<b>ITEM NUMBER</b>	6.1
<b>SUBJECT</b>	Pre-Gateway - Planning Proposal for 135 George Street and 118 Harris Street, Parramatta (Albion Hotel site)
<b>REFERENCE</b>	RZ/3/2017 - D06593442
<b>REPORT OF</b>	Project Officer-Land Use Planning
<b>LAND OWNER</b>	PIC Royal Investments Pty. Ltd.
<b>APPLICANT</b>	Think Planners

### PURPOSE:

**Figure 2: Cross section of previous Planning Proposal viewed from Harris Street towards to the west. The 2 towers to the south relate to the Cumberland Media site. (Source: previous Planning Proposal RZ/7/2015)**

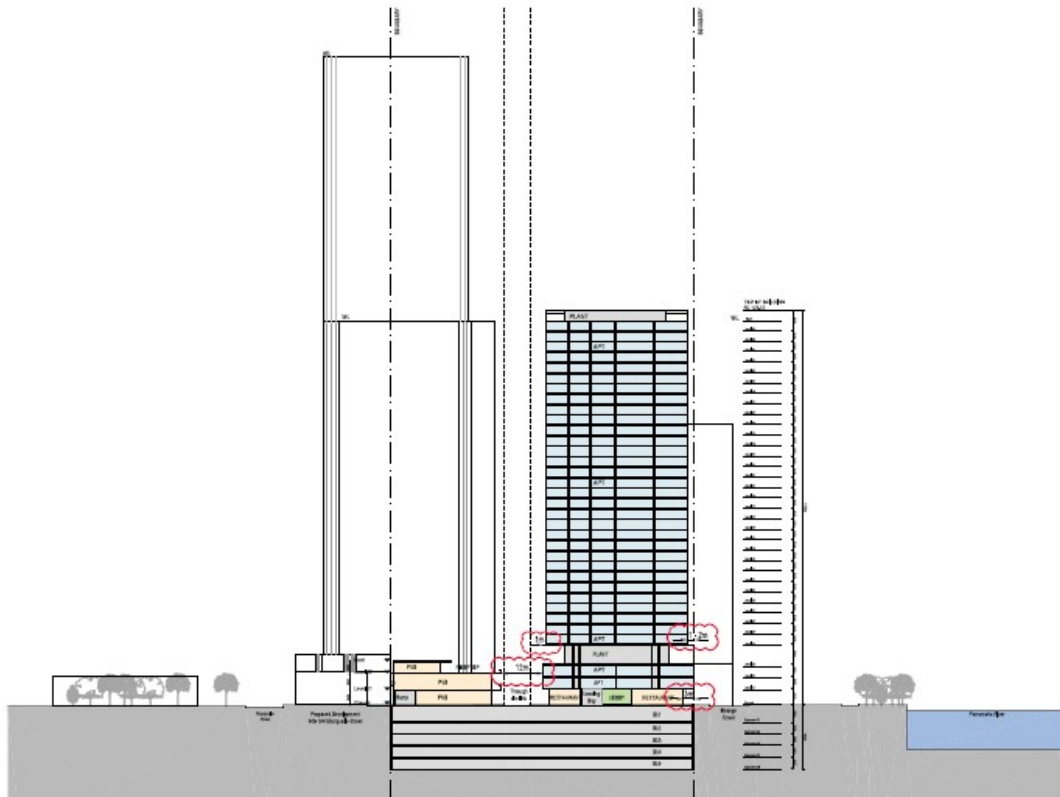
7. Figure 2 below shows an extract from the then applicant's Urban Design report indicating a cross-section from the reference design as viewed from Harris Street looking west.

**Figure 3: Applicant's reference design. Viewed from Harris Street towards the west. (Source: Applicant's Urban Design Report)**

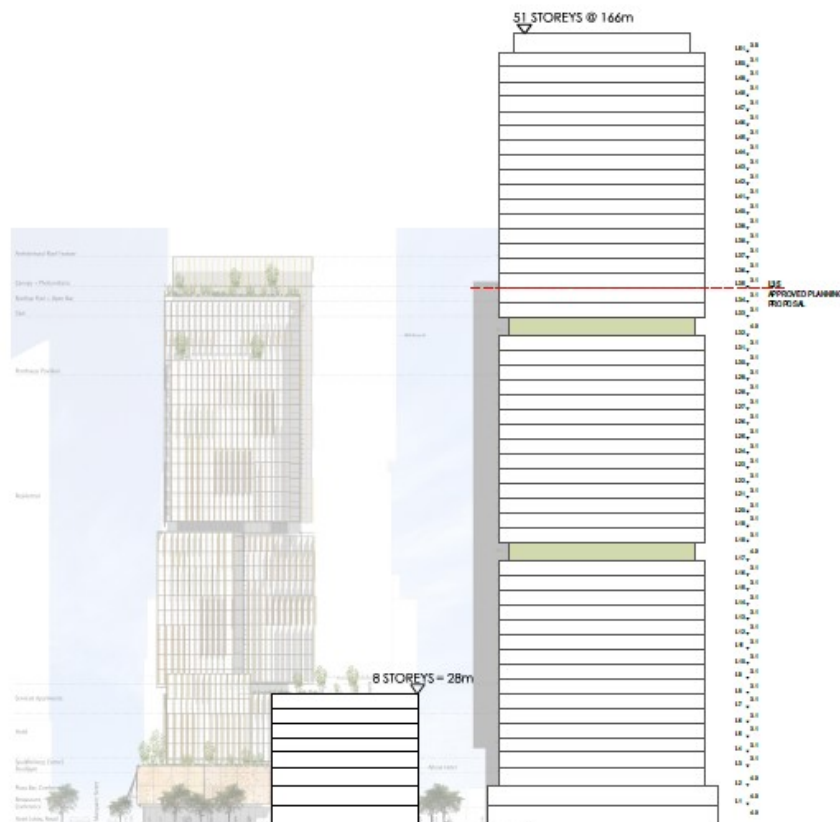
18. The applicant's urban design report (**Attachment 3**) includes a reference design that indicates a possible development that could be built with a total FSR of 13.5:1 and a height of 166 metres. An extract is shown in Figure 3 below.

19. The reference design proposes:
  - a. A 51-storey (166 metre high) tower (Building A) comprising:
    - 8 levels of basement car parking (shared with Building B) containing 507 car parking spaces;

- 2 levels of podium containing commercial floor space;
    - 49 levels of tower containing commercial and residential floor space. The residential consists of 488 apartments.

- b. An 8-storey (28 metres high) building (Building B) comprising:
    - 8 levels of basement car parking, (shared with Building A) containing 507 car parking spaces;

- 4 levels of commercial floor space; and
    - 4 levels of residential floor space containing 17 apartments.
  - c. The two buildings combined provide 3,620 square metres of commercial floor space and 38,710 square metres of residential floor space.

- (a) **That** Council endorse the Planning Proposal included at **Attachment 1** and **Attachment 2** for land at 135 George Street and 118 Harris Street, Parramatta which seeks to increase the maximum height of buildings control from 54 metres to 166 metres and increase the floor space ratio from 4:1 to 13.5:1, subject to the following amendments:

- a. Floor space ratio – reduction in the total floor space ratio from the applicant's proposed 13.5:1 to 12:1 including the design excellence bonus and the high performing buildings bonus, consistent with the CBD Planning Proposal previously endorsed by Council;

- (b) **That** the reference design be amended by the applicant to reflect the changes in (a) above prior to the Planning Proposal being forwarded to the Department of Planning and Environment. The shadow diagrams referred to in (a) above should be based on this reference design.

**Figure 4: Proposed route of the Parramatta Light Rail in relation to the subject site. The platform location is shown coloured purple. (Source: Council's GIS).**

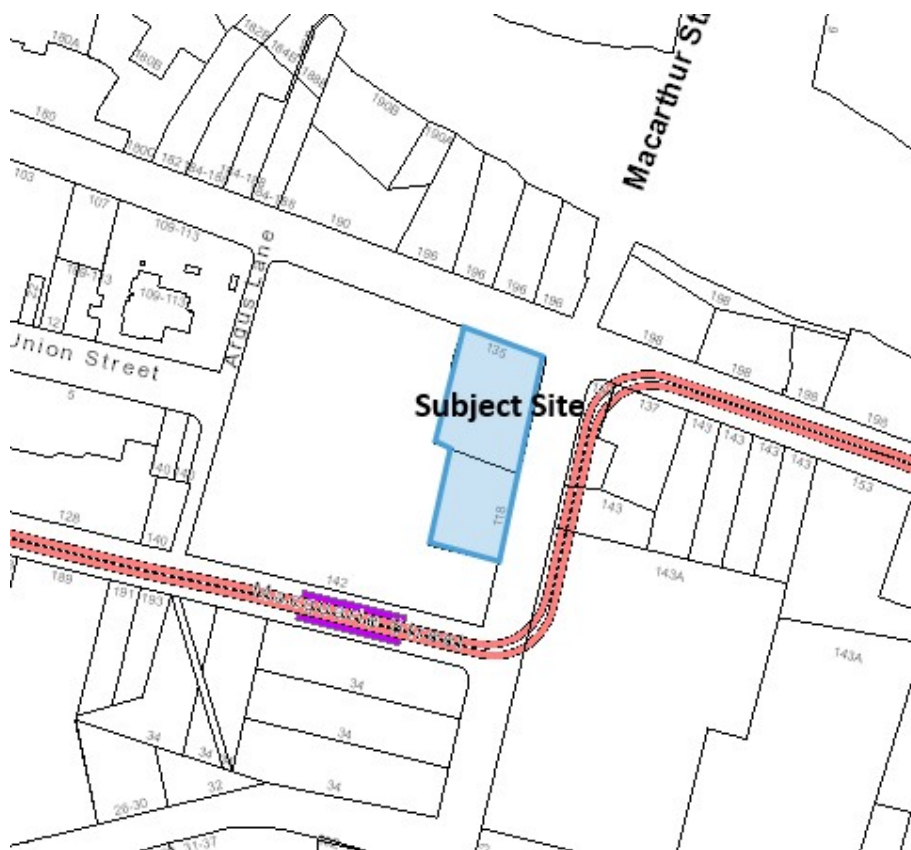
20. The site is near the route for the Parramatta Light Rail (PLR). Figure 4 below indicates the route in relation to the subject site. As the route is on the opposite side of Harris Street, land acquisition on the site is not required specifically for the PLR.

21. However, consultation with the Roads and Maritime Services (RMS) as part of the Parramatta CBD Planning Proposal has identified a potential need for a seven metre wide land acquisition area on the subject site to facilitate the duplication of the Gasworks Bridge. The location of the PLR route on the eastern side of Harris Street means that the subject site is the only available location for this road widening.

23. The applicant's revised Planning Proposal now reflects the seven metre road widening and shows the development as being clear of this road widening area. The applicant has responded to the road widening by shifting the podium and the tower to the west. The floor space ratio has been calculated based on the current area of the site, including the road widening, so floor space can be transferred from the road widening area on the site.

**Figure 6:** Planning Proposal for the Albion Hotel site in context with Planning Proposal for the adjoining site - Cumberland Industries site (Source: Applicant's Urban Design report).

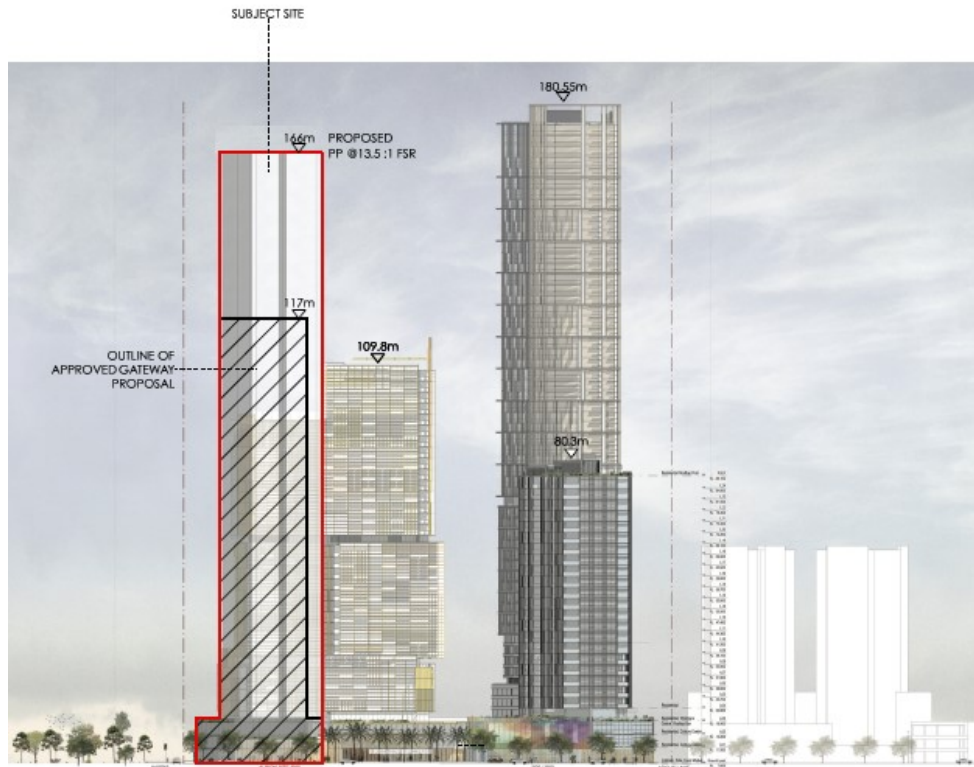
27. Critical to the success of the whole block is the new pedestrian links and the new shared zone running through both sites which extends Union Street to the west. The area between Building B25 on the adjoining site and the tower at the northern end of the subject site, shown with no shading in Figure 5, is proposed public domain.
28. Figure 6 below shows the entire block when viewed from George Street looking south. The indicative tower for the subject site is outlined in red. The previously endorsed Planning Proposal which has since lapsed is shown hatched.

42. Comments from Council's Urban Design team are summarised below:
  - a. It is noted that the site previously underwent a master planning exercise in conjunction with the adjoining Cumberland Industries site. The previous Planning Proposal for the site reflected this block-wide approach to planning. The densities were formulated from this approach and the overall scheme of tower heights and building massing on the site were considered on a broader block basis.

- b. This process resulted in the identification of a shared zone, two pedestrian paths and a public domain. There is a risk that increasing the density, height and changing setbacks on the subject site compromises the urban design and public domain outcomes envisaged by this block-wide approach.

- c. In particular, the nil western tower setback is of concern as it creates a sheer tower without relief that will impact negatively on the proposed public domain on the Cumberland Industries site. However, it is noted that the 7 metre road widening on Harris Street has made it difficult for the site to accommodate setbacks on the western side, and as such, some concessions are considered reasonable. The planning proposal recommended for endorsement is based on a reference design with a 3 metre tower setback to George St.

44. To determine how the setbacks issues above will be resolved it is recommended that a site-specific Development Control Plan (DCP) be prepared which addresses setbacks and the relationship with the Cumberland industries site.
